SECTION 00 91 16

ADDENDUM NUMBER 7

- 1.01 DATE: APRIL 12, 2021
- 1.02 PROJECT: WELCOME CENTER
- 1.03 PROJECT NUMBER: DCM NO. 2020604
- 1.04 OWNER: ALABAMA A&M UNIVERSITY
- 1.05 ARCHITECT: NOLA | VAN PEURSEM ARCHITECTS, PC

NOTES:
1- PLUS AND MINUS SIGNS DENOTE PRESSURE ACTING TOWARDS AND AWAY FROM BUILDING SURFACE
2- ONE-THIRD STRESS INCREASE IS NOT ALLOWED.

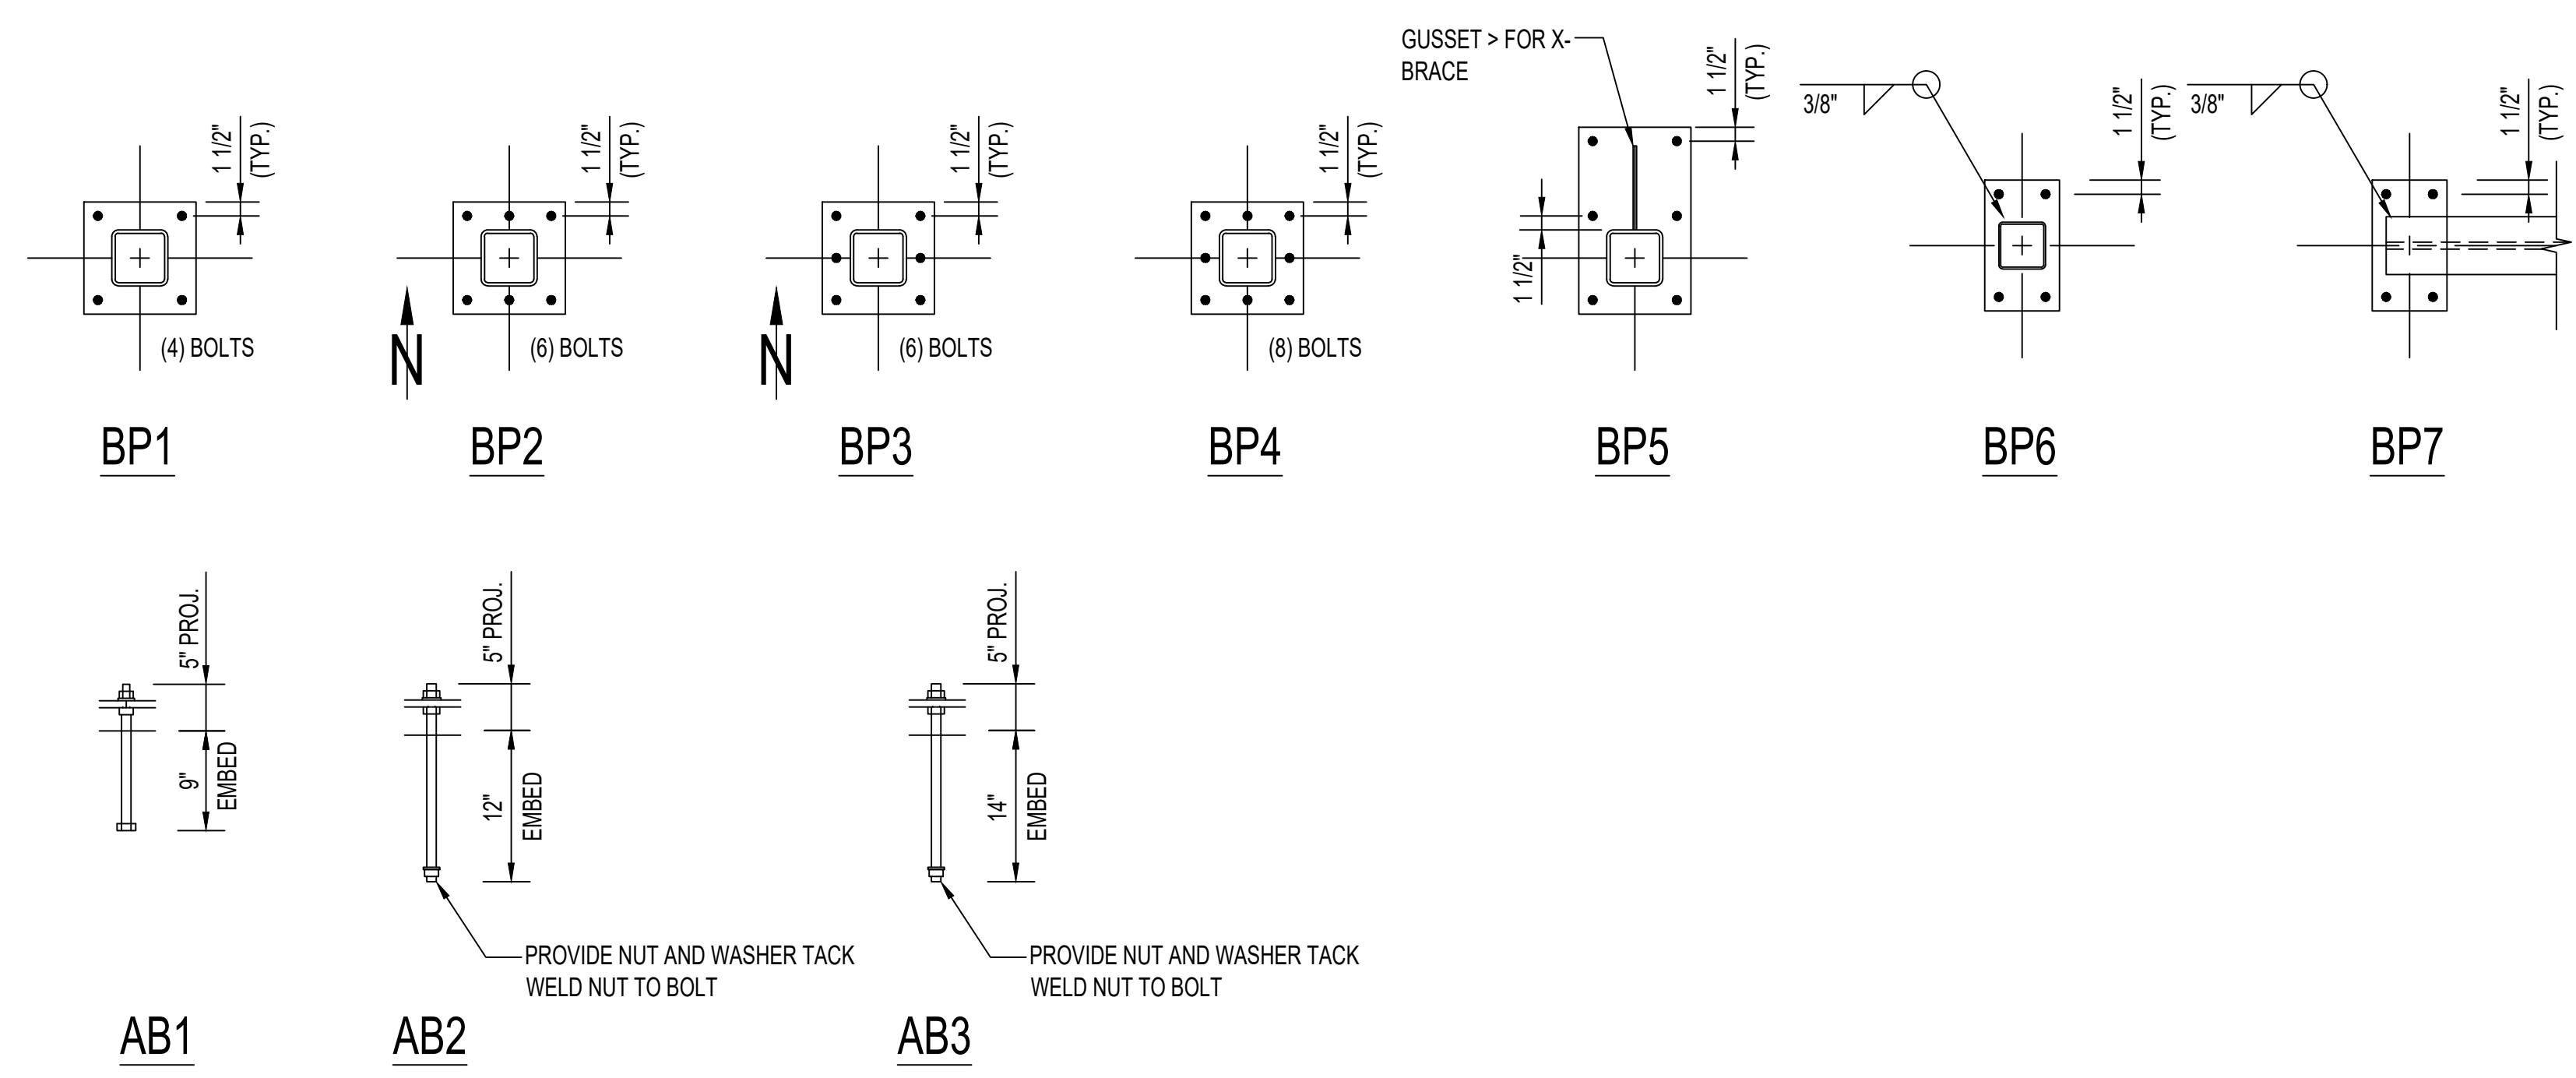
- A. Replace this Sheet in its Entirety. Revisions include the following:
1. Added wind beam data
 2. Revised columns with high level finish.

ELEVATION E1
SCALE 3/8" = 1'-0"
S4.0

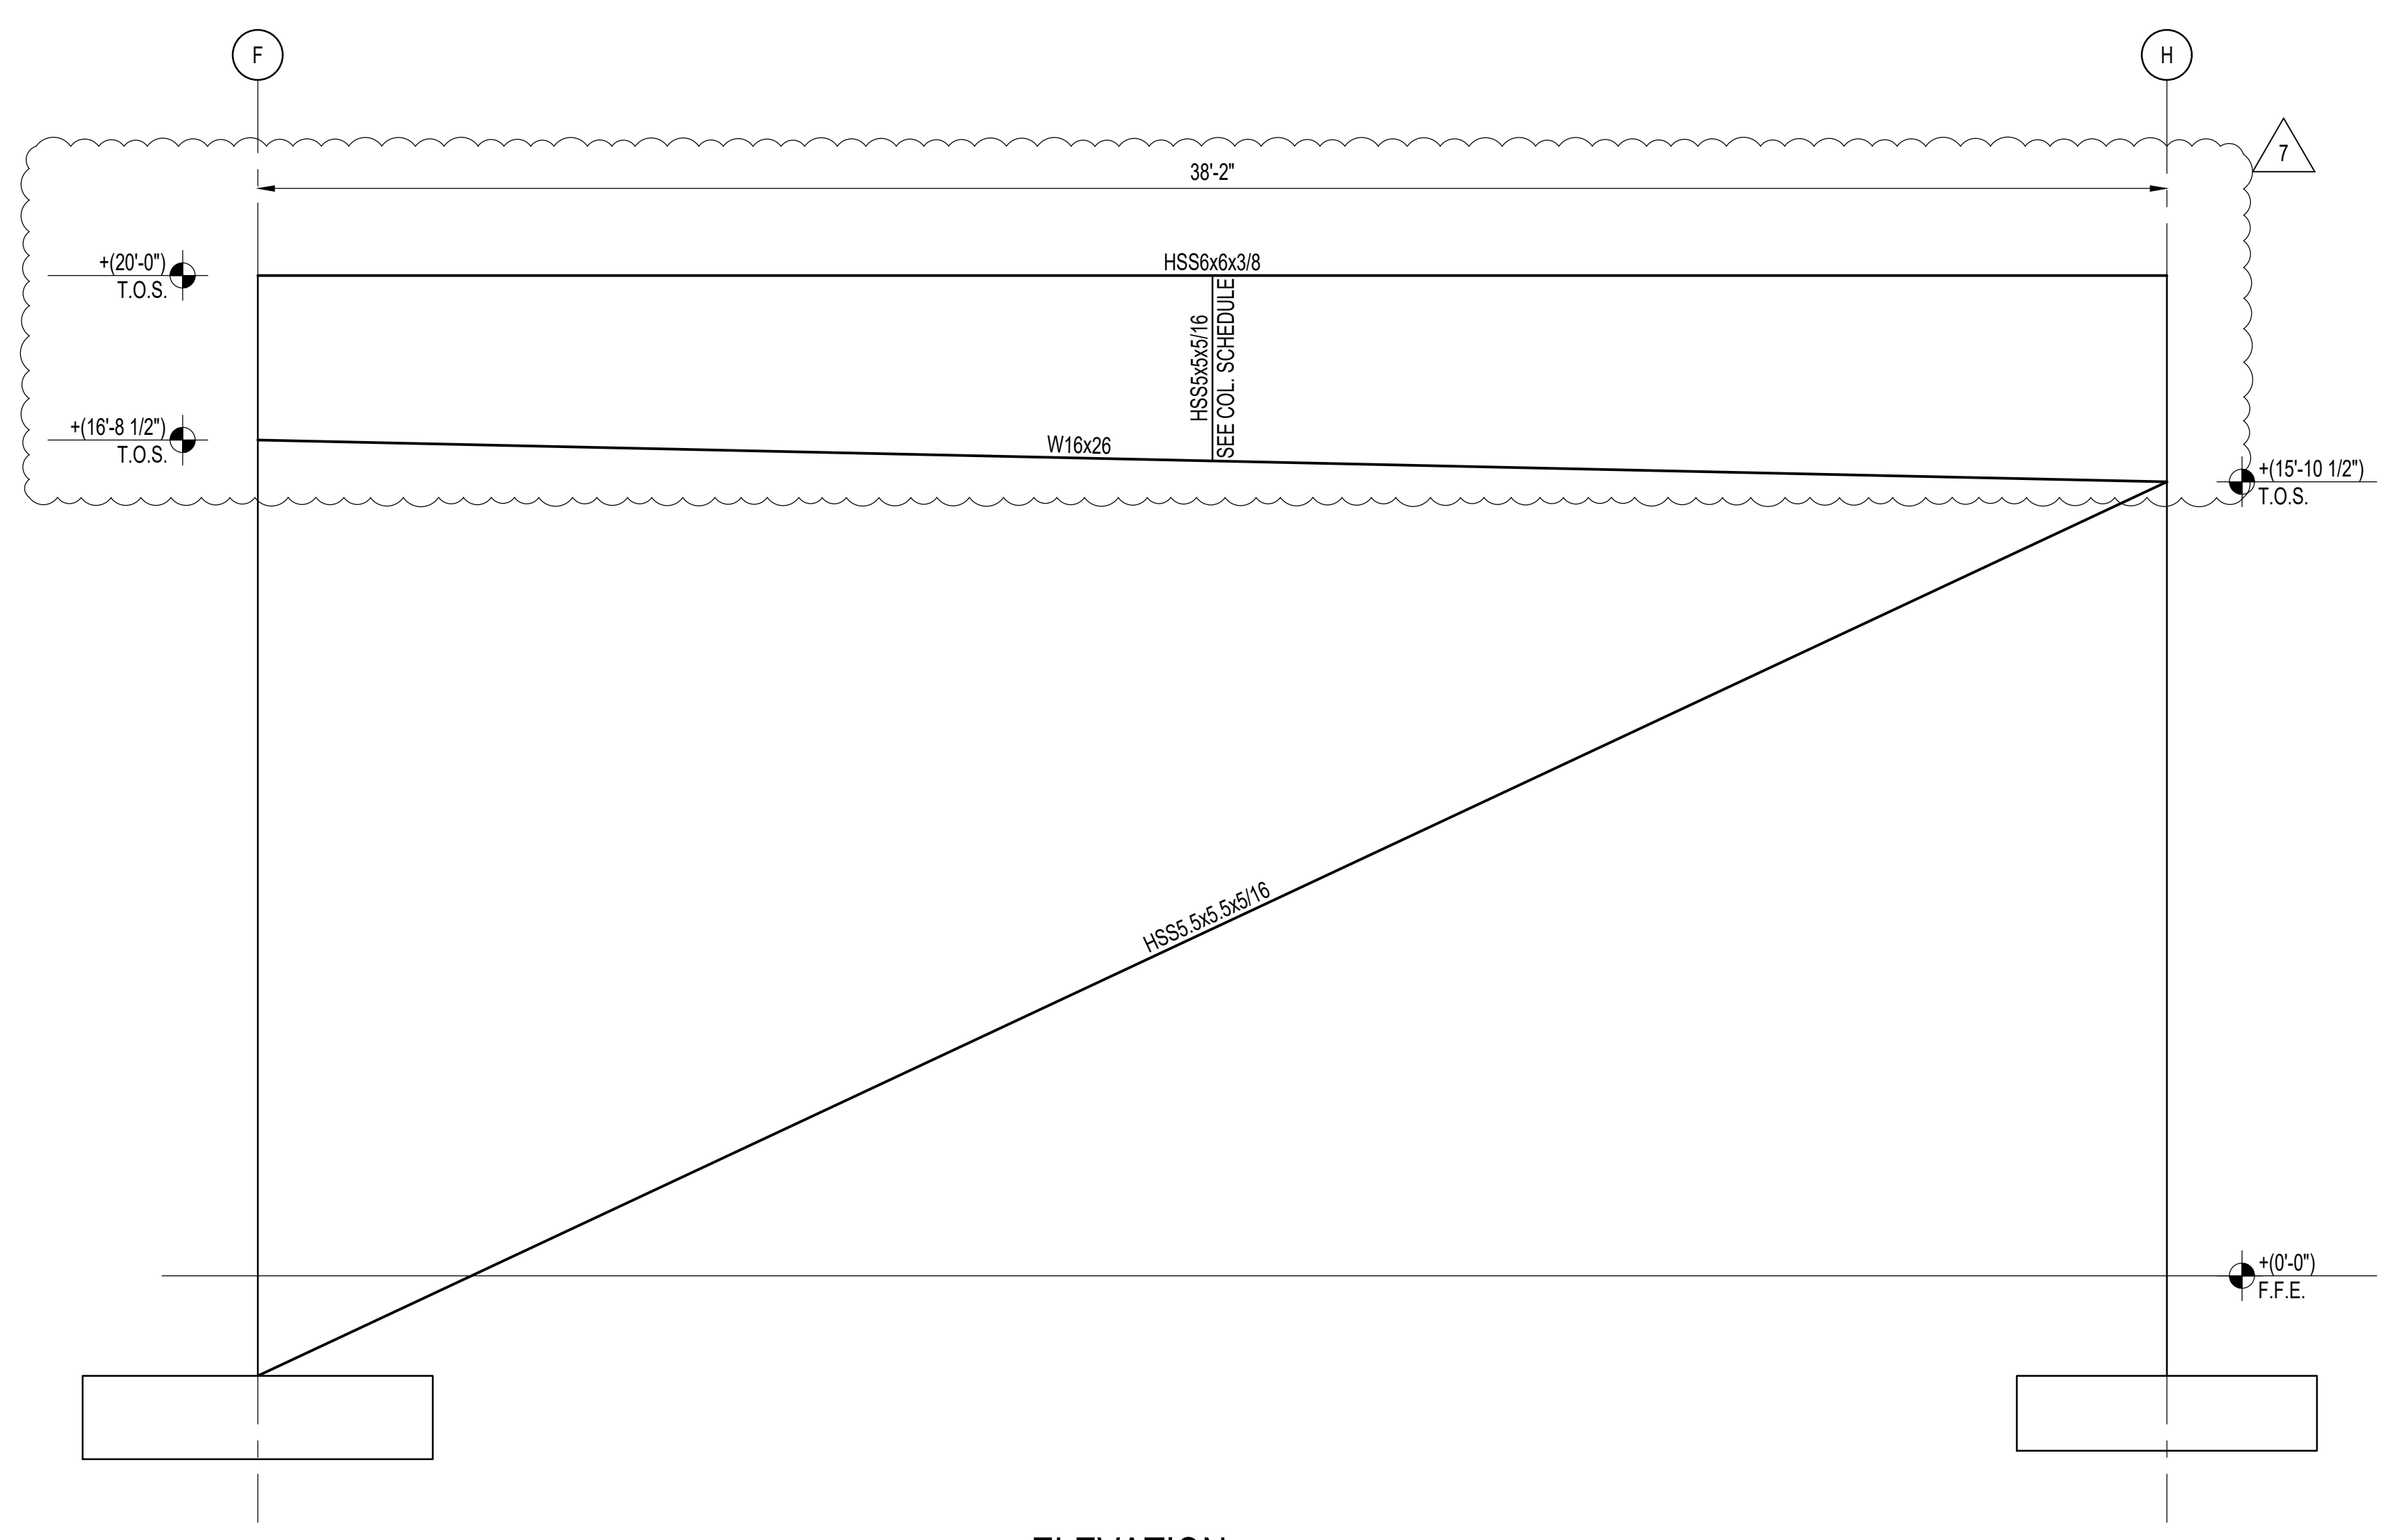
- A. Replace this Sheet in its Entirety. Revisions include the following:
1. Added wind beam at E1/S-4.0.
 2. Added drawing tag at section A/S-4.0
